Detection Timing

Andy Gardner

Problem 1: Min I_{valid} Is Too Low

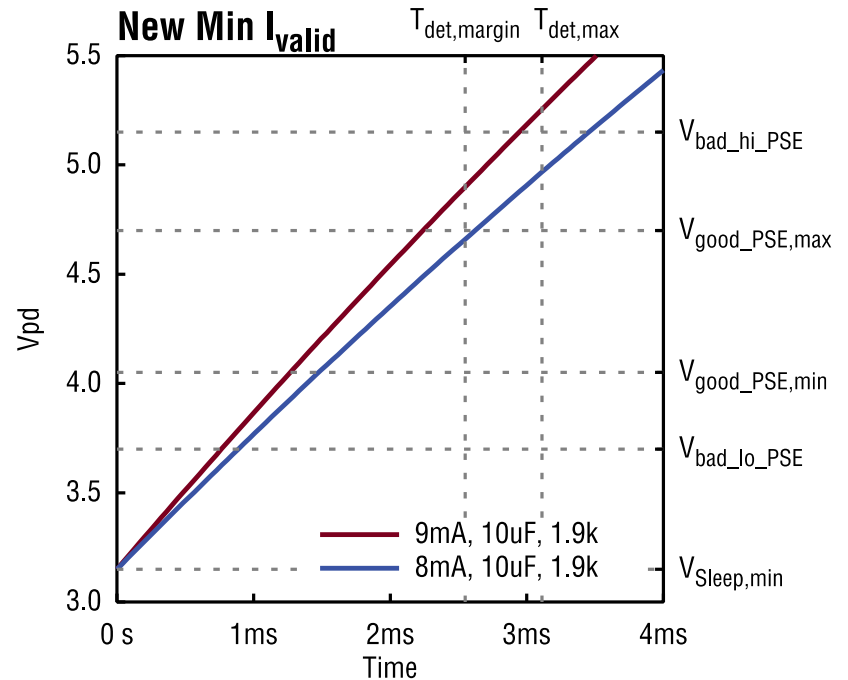
- 8mA Detection Current into minimum PD impedance does not exit the detection window before $T_{\text{det,max}}$
- $T_{\text{det,margin}} = T_{\text{det,max}} / 1.22$
- Increase $I_{\text{valid,min}}$ to 9mA

Problem 2: $T_{sig_hold,min}$ is too short

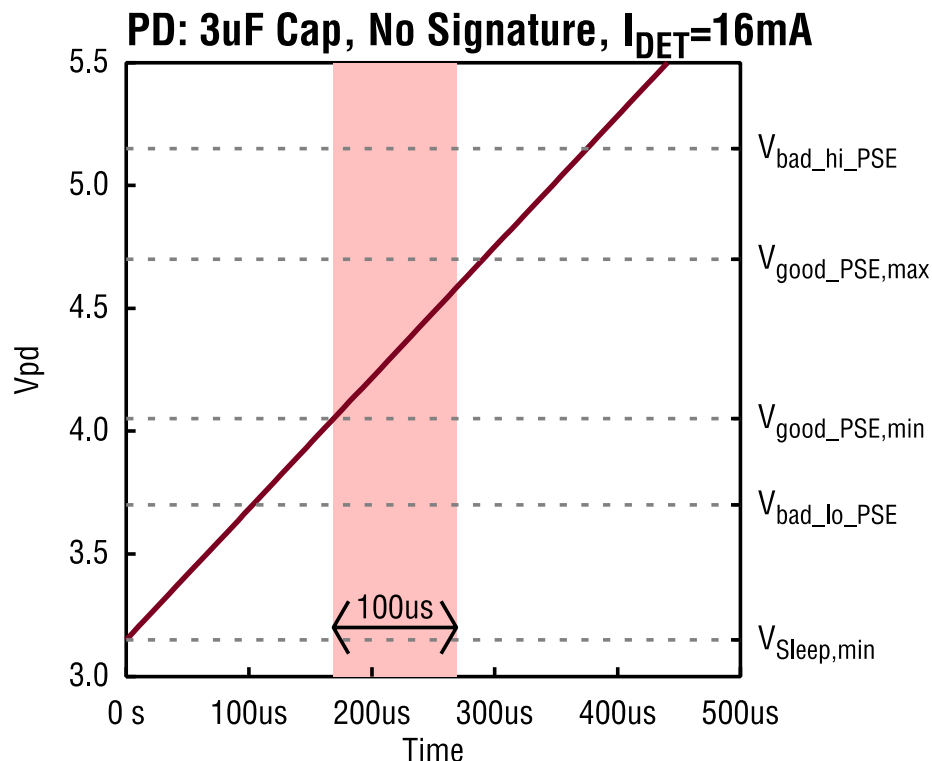
- PD without signature
- $C_{pd} > 2.46\mu F$
- Accepted as Valid PD

Increase $T_{\text{sig_hold,min}}$ to 1ms

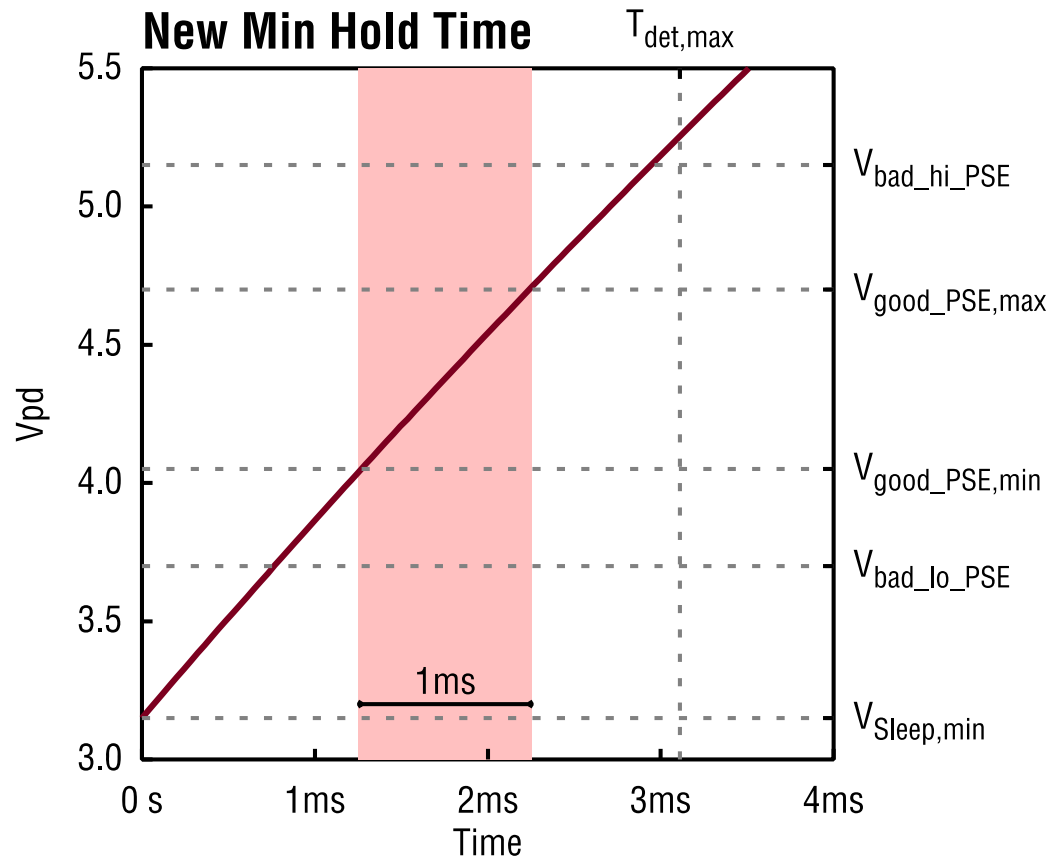
- Determine $T_{\text{sig_hold,min}}$ as smallest PSE detect current into smallest valid PD impedance
- $I_{\text{detect}} = 9\text{mA}$
- $C_{\text{pd}} = 10\mu\text{F}$
- $R_{\text{wake}} = 1.9\text{k}$
